Holme Hale Parish Council – Input to High Grove Solar Farm Statutory Consultation

Given the proposals documented to-date by RWE regarding the proposed High Grove Solar Farm development, the following is a summary of the concerns held by Holme Hale Parish Council (HHPC). In the main they relate to the proposed plans for the construction and subsequent operation of the proposed High Grove Southern Panel Area.

Fig.1 HHPC recommended access route(s) for High Grove Construction Traffic (*as denoted by Blue lines*)

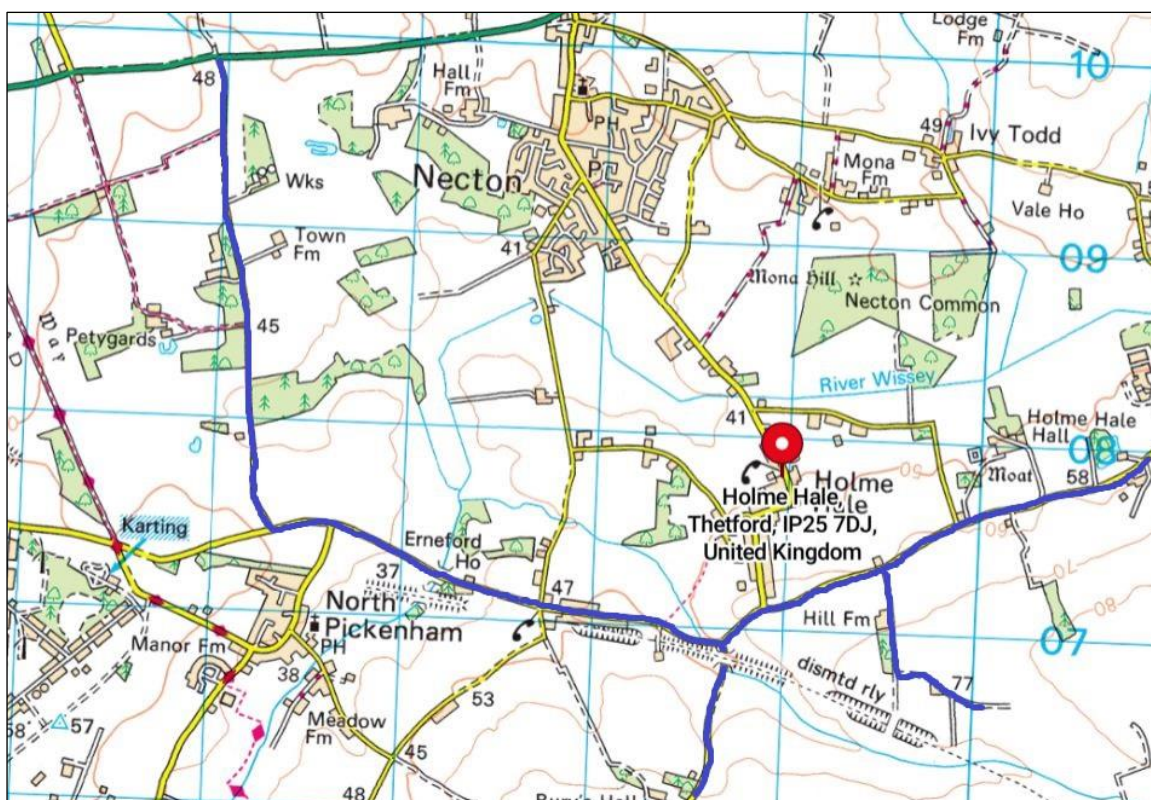
HHPC are of the view that both Lower Road and Brown's Lane are unsuitable for use by HGV traffic involved in construction of the Southern Panel Area. These are narrow single-track roads, whose carriageway width and underlying sub-base is incapable of accommodating and sustaining the frequent passage of HGV traffic. Lower Road also contains a NCC-designated Roadside Nature Reserve of ecological importance. As such we do not believe that these roads should be used as designated access routes for traffic associated with the High Grove development.

HHPC recommends that a more practicable option would be to route HGV construction traffic from the A47 via the North Pickenham Road (*past Petygards Hall*), this being the designated HGV access route from the A47 to the North Pickenham Industrial Area. It could then be routed along the C117 Station Road / Bradenham Rd to the Holme Hale, (West) Bradenham and Ashill access points of the Southern Panel Area (*see Blue line(s) on Fig.1*).

Fig.2 HHPC proposed locations for provision of additional HGV passing bays (as denoted by Red boxes)

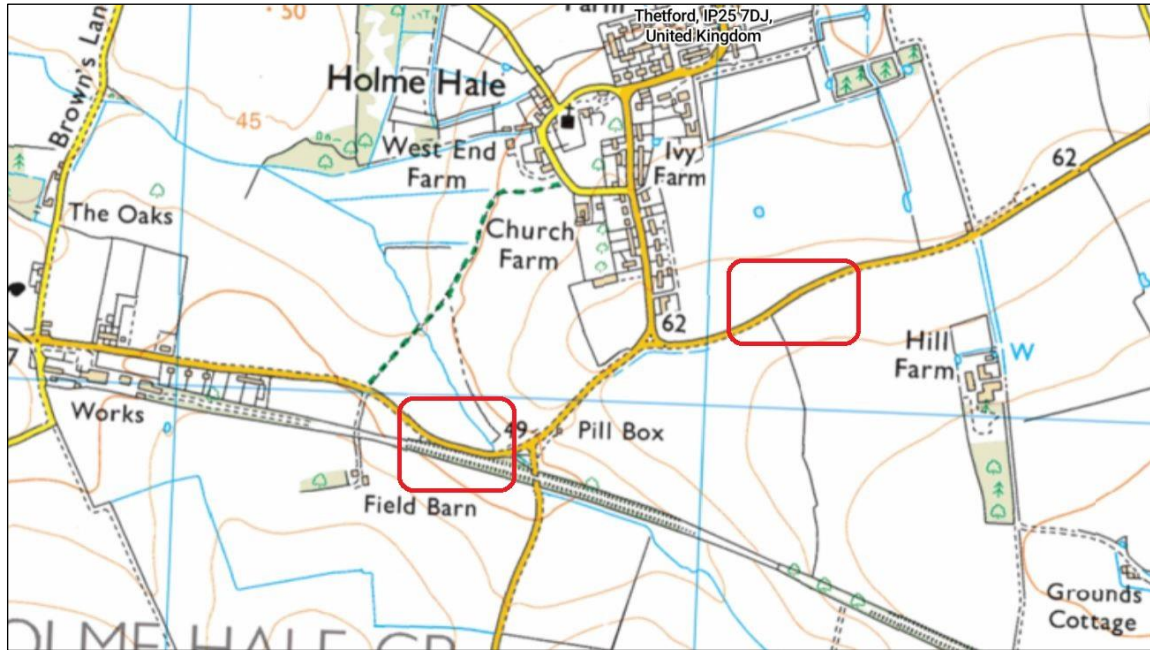
In order to go some way to mitigate disruption likely to result from the undoubted increase in HGV traffic along Station Road and Bradenham Road (Holme Hale), HHPC requests that RWE consider the installation of additional (HGV) passing bays in sections of this route within Holme Hale Parish (see Fig.2), specifically:

- i) On Station Road, before the Ashill / Hale Road junction (*where the road narrows*), and
- ii) In the particularly narrow section of the Bradenham Road (*incorrectly marked as Station Rd*) between the junction with School Road & the entrance to Hill Farm.

Fig.3 Viewpoints of concern to HHPC (*as denoted by the Blue arrows*)
- Orange line indicates location of proposed tree planting

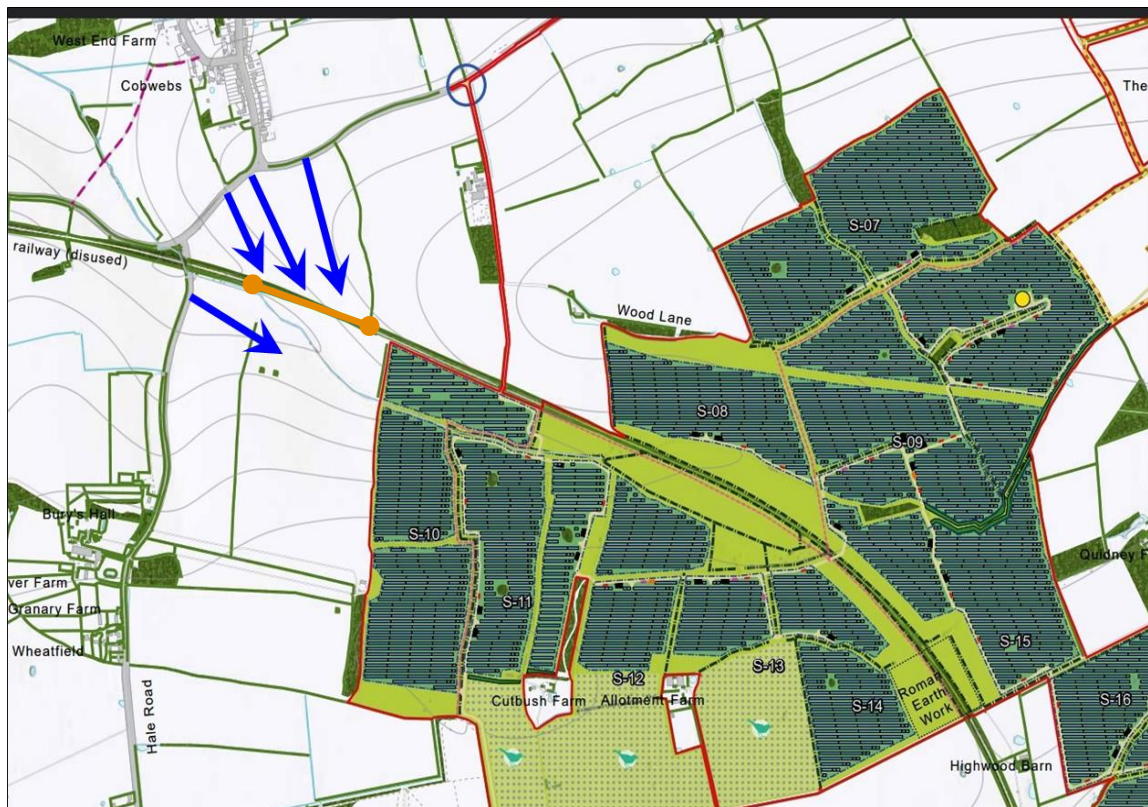
HHPC are extremely concerned that areas of proposed Southern Development Area (*particularly parcels S-10 & S-11*) will have an adverse impact on the visual amenity of Holme Hale Residents when viewed from the following locations (*see Fig.3*):

- Holme Hale Pavilion Playing Field
- The roadside pedestrian footpath which extends around the eastern and southern periphery of the HH Playing Field
- The Permissive Paths which extend along the roadside field margins of the:
 - Bradenham Road (*incorrectly marked on maps as Station Road*)
 - Ashill Road, Holme Hale (*marked as Hale Road*).

However, HHPC is of the view that, due to the elevated topography at the southern sections of the S-10 and S-11 parcels, the additional screening measures proposed by RWE within the site boundary (*at lower elevations*) will not provide sufficient visual mitigation from the majority of viewpoints cited. Additionally:

HHPC therefore requests (*as previously discussed with RWE*), that RWE implements the establishment of additional screening outside of the proposed Draft Order Limits (DOL), to minimise the likely visual impact of the S-10 and S-11 parcels when viewed from the immediate locality of the HH Playing Field and adjacent Permissive Paths.

We are firmly of the opinion that these measures should include the establishment of an avenue of semi-mature trees (*a deciduous & evergreen mix*) along on the upper surface of the embankment of the Disused Holme Hale to Watton Railway Line (*see Orange line in Fig.3*). It is understood that the landowner in question is amenable to a development of this nature.

Fig.7 RWE proposed location substation infrastructure in Southern Development Area (Yellow circle)
 - Proposed site is almost on the highest available location in the locality (~86 m elevation)

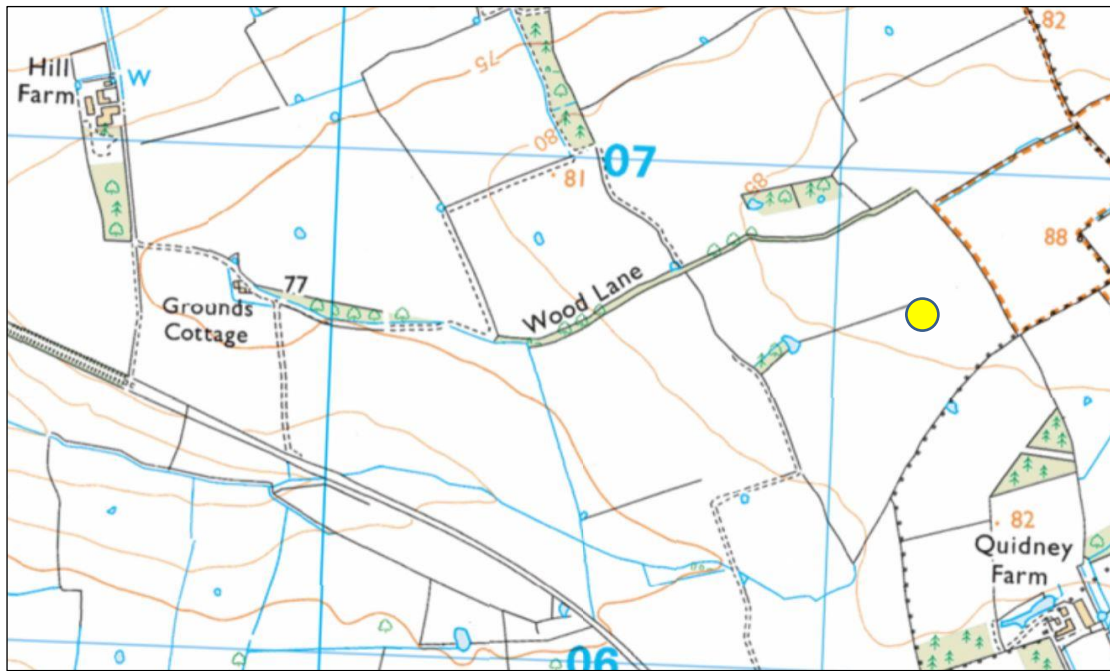
HHPC is concerned regarding the proposed location of the (Southern Area) 132kV substation. It is noted that at present RWE propose to site this permanent infrastructure within the S-09 Panel Area on almost the highest point in the local vicinity – at an elevation of ~86 metres (see Fig.7).

HHPC fears that this proposed siting will both increase the visual impact of the installation on the locality (in terms of remote visibility of light emissions) and potentially enhance the propagation of noise emissions from the infrastructure on the site.

HHPC therefore requests that RWE explores the possibility of relocating this substation installation to a lower point in the proposed field (i.e. in direction the Red arrows – Fig.6), to reduce the inevitable impact of light pollution on the locality and the propagation of noise emissions from the site.

HHPC also requests that RWE implements one or more of the following mitigation measures in order to address our very real concerns regarding the proposed siting of this infrastructure:

- The provision of a raised earth bund on the western side of the substation site
- The planting of a (semi-mature tree) screening belt on the northern, western & southern sides of the proposed infrastructure site
- Augmentation of the adjacent hedge which bisects the S-09 Panel Area **and** planting of additional woodland parcel(s) to the west of the proposed infrastructure site.
